Guelph/Eramosa Township Hydrogeology Agency Review Document Book

Hydrogeology Review Document Book Index

Re: Harden Response Letter Dated June 12, 2015
Project No.: 300032475.0000

**Re: JDCL Response to Hunter and Associates May 15, 2015 Peer Review
Project No.: 300032745.0000**

Fig 1.6

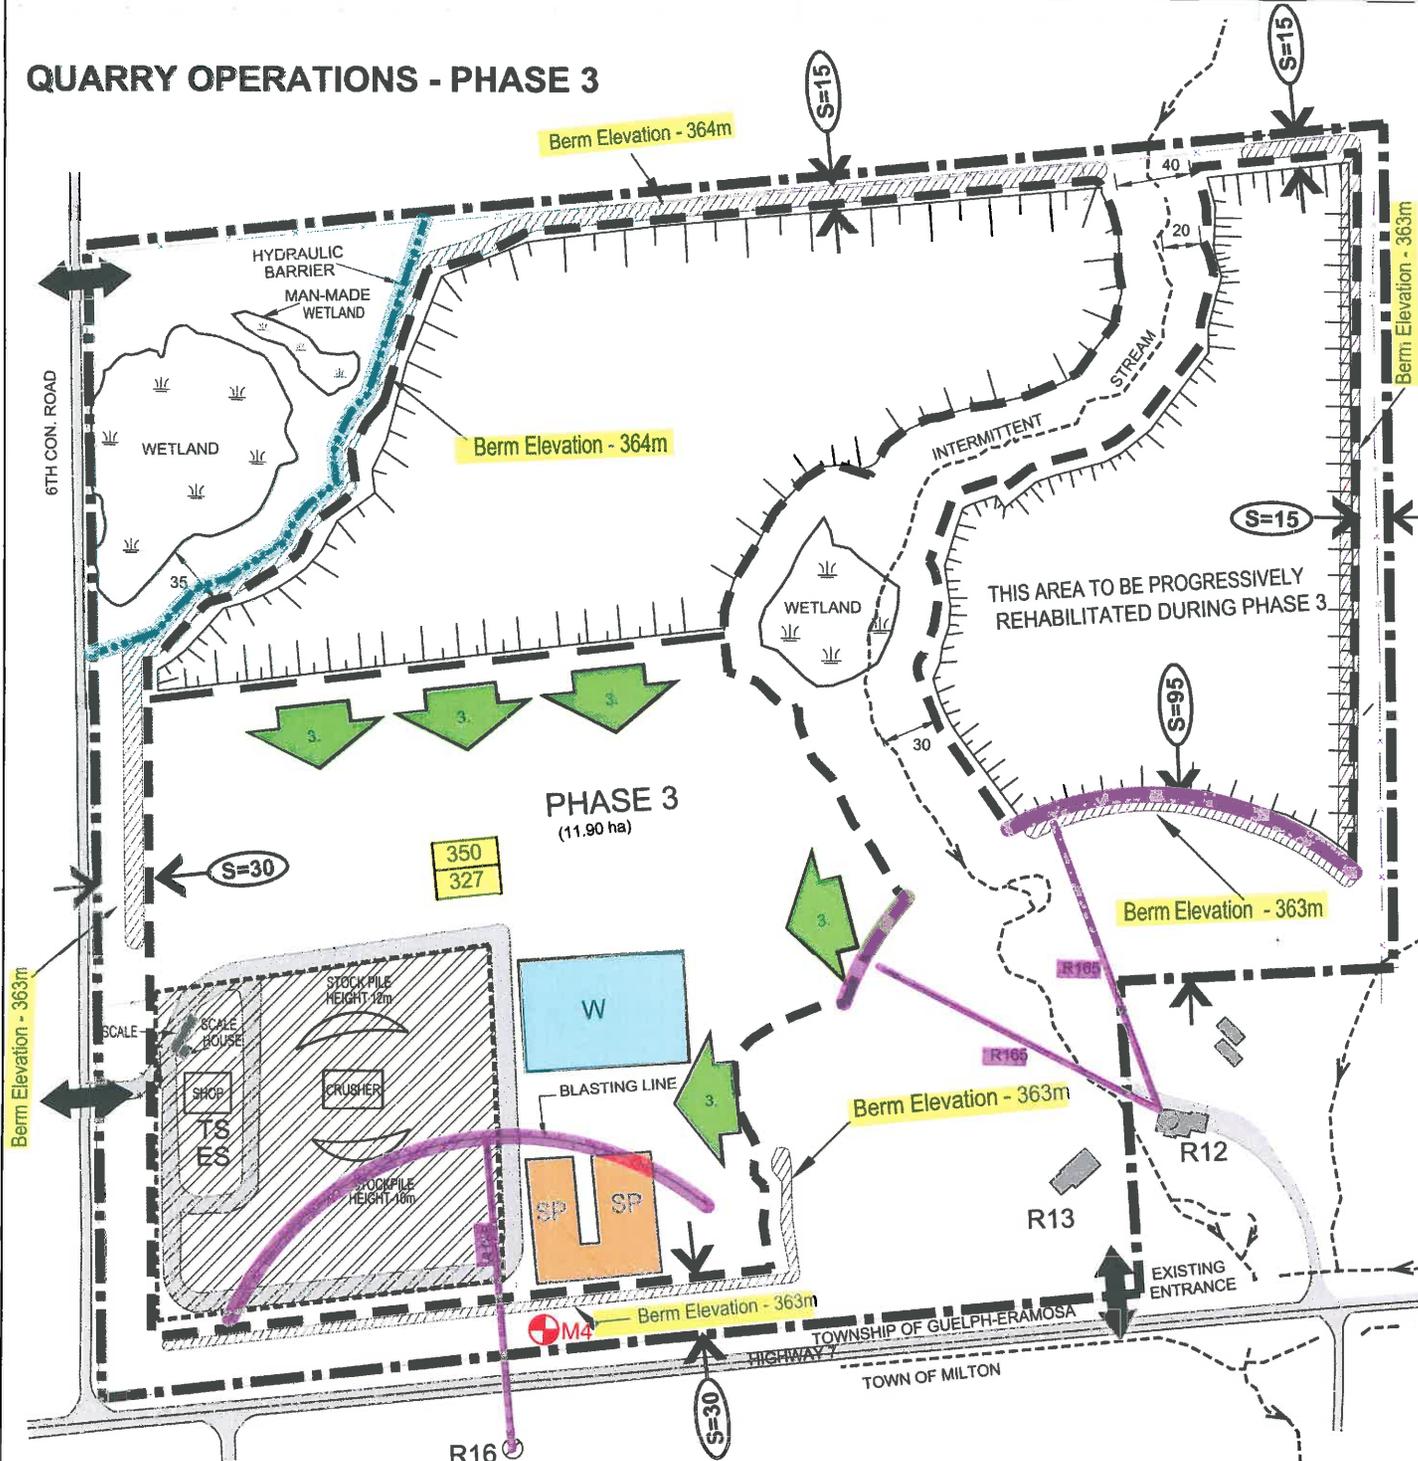
The March 19, 2015 Site Plans (Fig 1.2, 1.3, 1.6 and 1.8 enclosed) do not show the processing area operational pit floor and internal haul roads at 349 m asl as recommended by the Noise Study. The Noise Report sample noise calculations for Receiver R3 (W5) utilizes the operational pit floor staging area elevations. These elevations are illustrated in more detail on Fig 1.5. The presumption, although not stated, is that these are dry pit floor elevations.

- The Applicant has elected to initiate Phase 1 dolostone subaqueous extraction in the upgradient high water table area on the north side the quarry (Fig 2.2). The Site Plans specify the operational staging pit floor at the approximate top of bedrock at 349 m asl elevation (Fig 1.6).

Fig 1.6 The Noise Report recommended establishing the Processing Areas and Internal Haul Roads at 349 m asl (also Fig 1.5). These 349 m asl pit floor elevations are specified in the Phase 1 area but not on the corresponding internal haul road and processing area locations on the Applicant Site Plans.

Fig 2.2

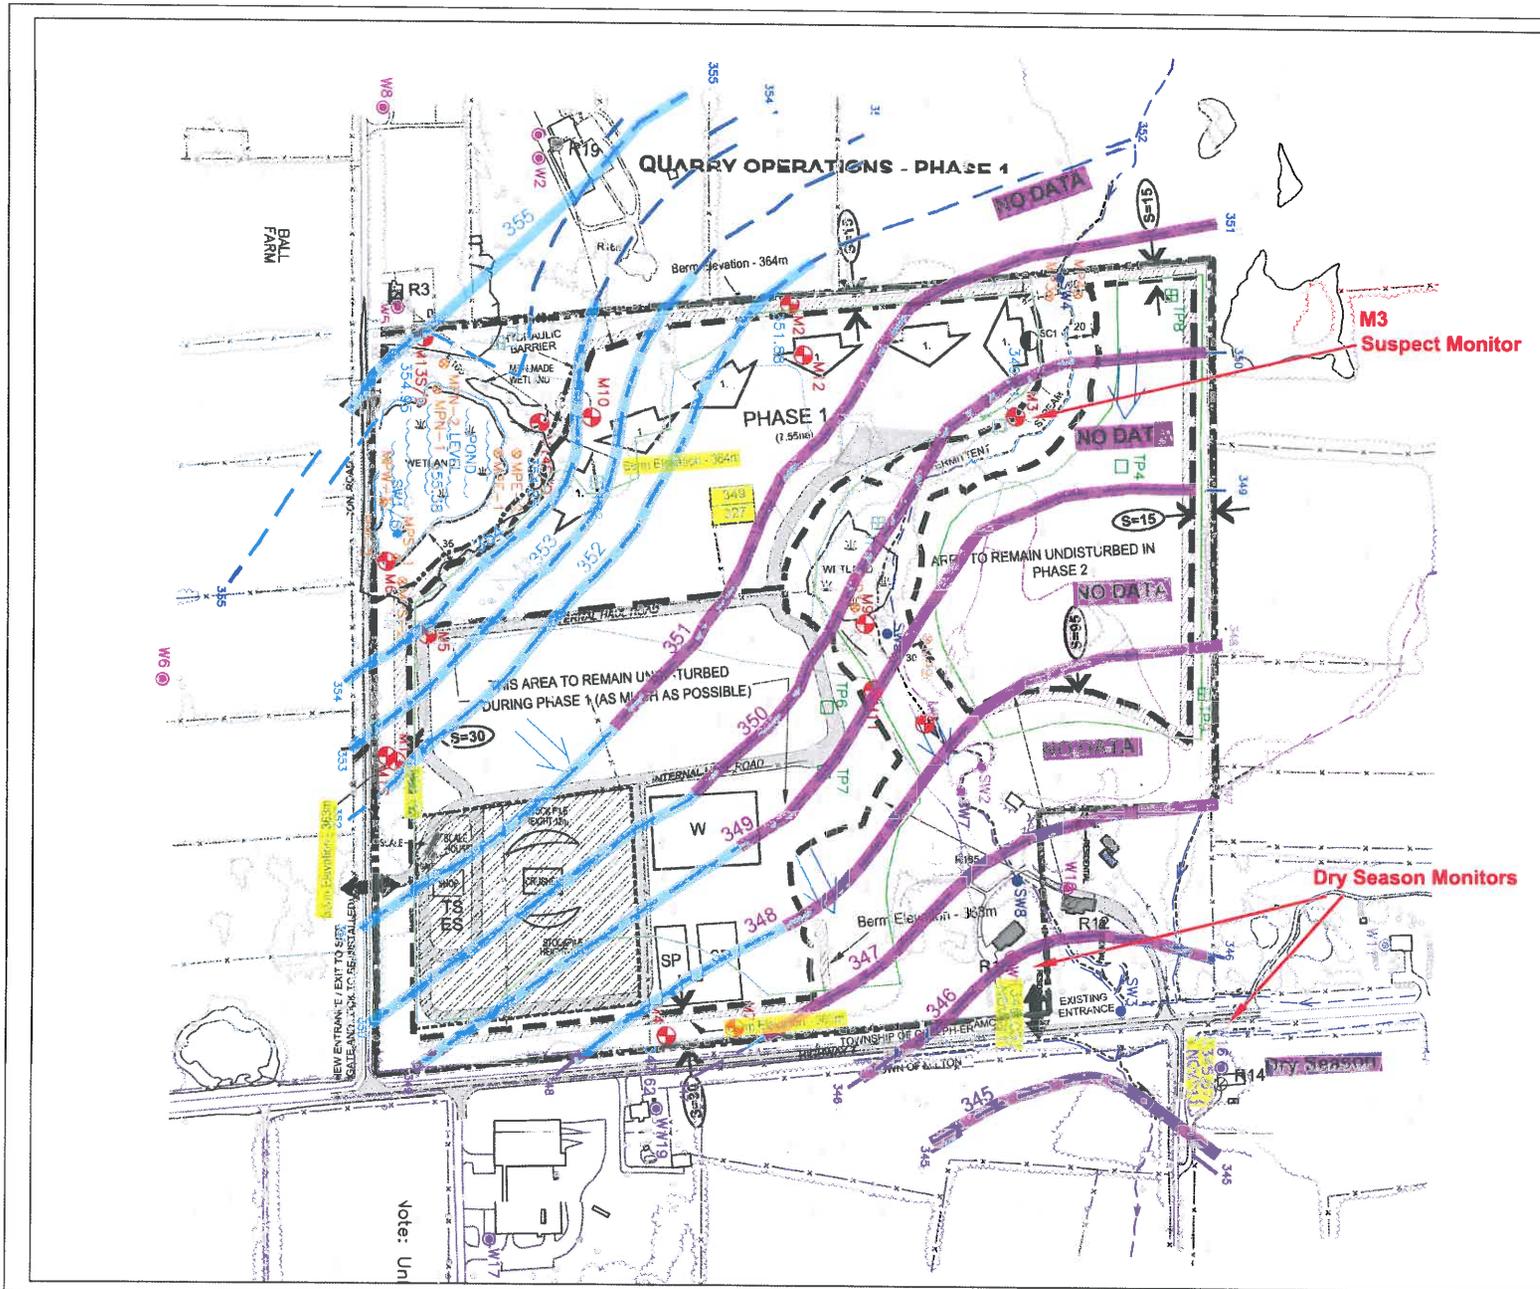
Fig 2.1 Fig 2.1 shows the location of recommended new multi-level monitoring wells constructed similar to M15 which will be destroyed by Phase 1 extraction. M16, M19, M20 and M21 to M15-2 aquifer are required to support new groundwater model runs prior to aggregate licence approval. M18, M22, M23, M24 and M25 are required well in advance of on-site passive or active water table disturbance. M17 is an optional replacement for deep long term monitor M2. M24 is required to replace Monitor M1-D as an openhole monitor to the proposed quarry floor elevation. M25 provides for monitoring water levels upgradient of the Brydson Creek headwater. See s6.1 for additional information.

Fig 2.3A

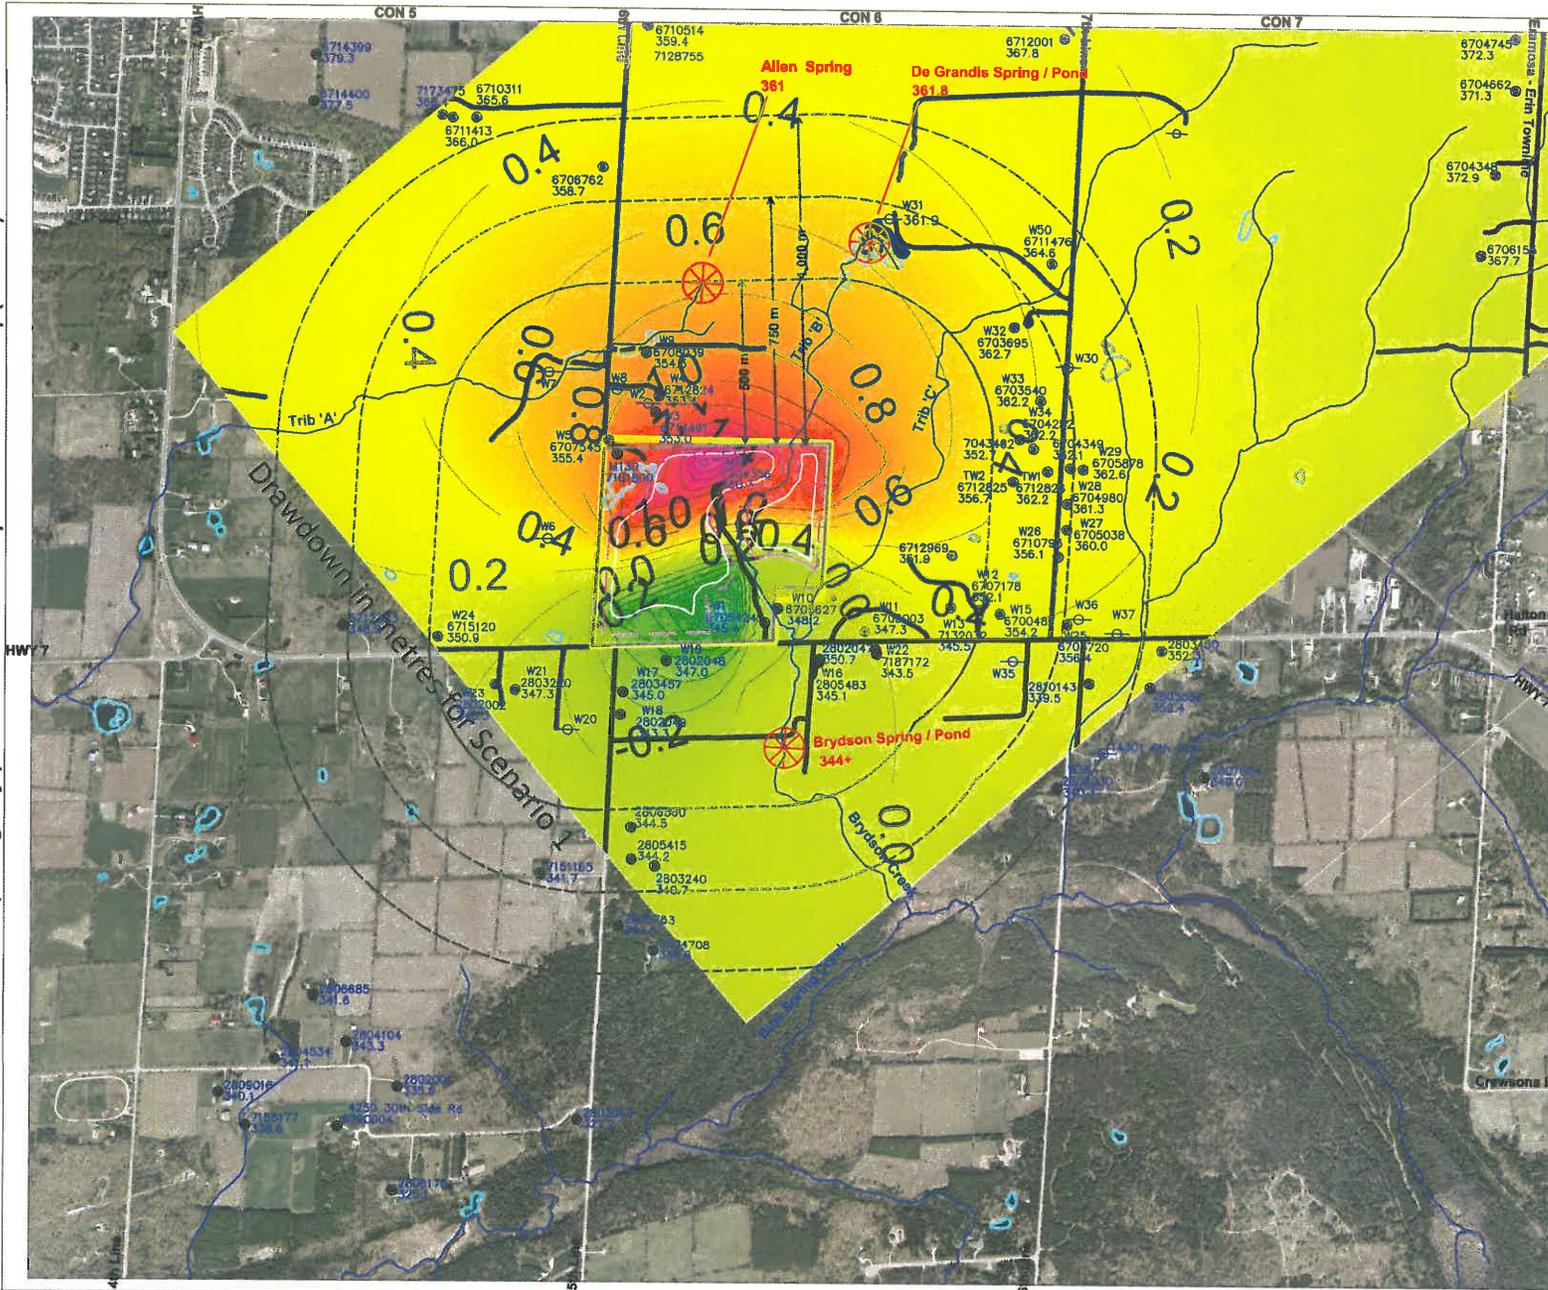
Fig 2.3A Furthermore, the drawdowns shown on Fig 2.3A are post-extraction not operational drawdowns. The Applicant's groundwater model predictions are 'flawed' by its inferred model calibration data (Fig 2.2). For purposes of this Peer Review, I have applied a factor of safety of 2x to the Applicants predicted drawdowns north of the proposed quarry, therefore a 0.6 m drawdown is assumed at 1.2 m for impact assessment purposes. The contour 'bulls-eyes' or 'pimples' in the proposed quarry area indicate data anomalies or errors. The Applicant has refused to provide Hunter with its modelling groundwater level datasets for audit. The Model needs to be recalibrated and rerun prior to Site Plan approval.

Fig 2.4A

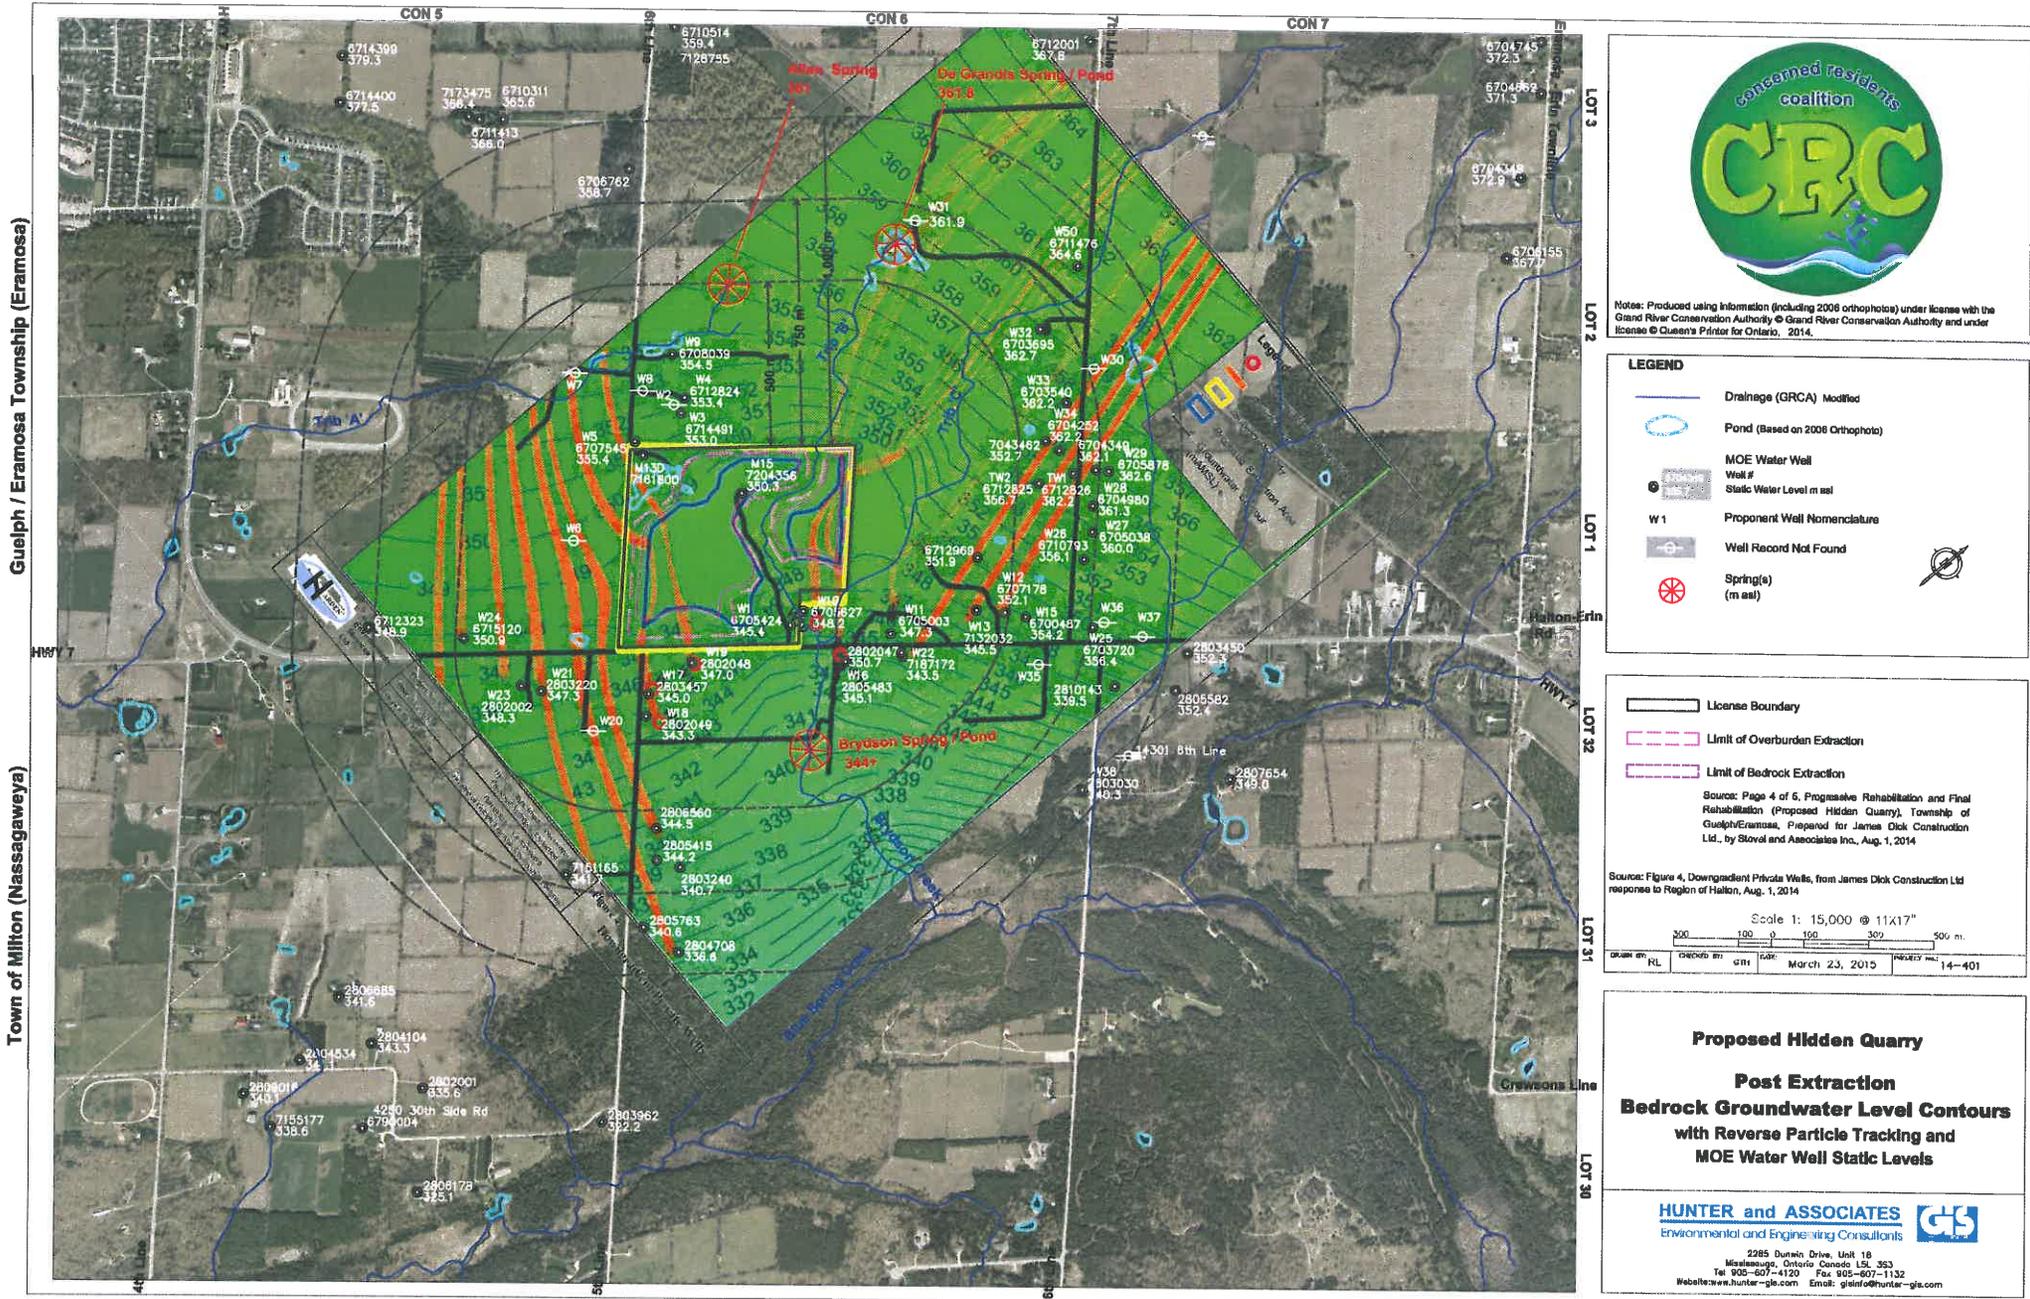
Fig 2.4A This Figure shows the Applicant's modelled bedrock water level contours and reverse particle tracks showing the predicted flow origins of water to domestic wells. These are post-extraction, not operational drawdowns. At face value the reverse particle tracks show that domestic wells W10, W16, W17, W18 and W19 are within the direct quarry water quality influence zone.
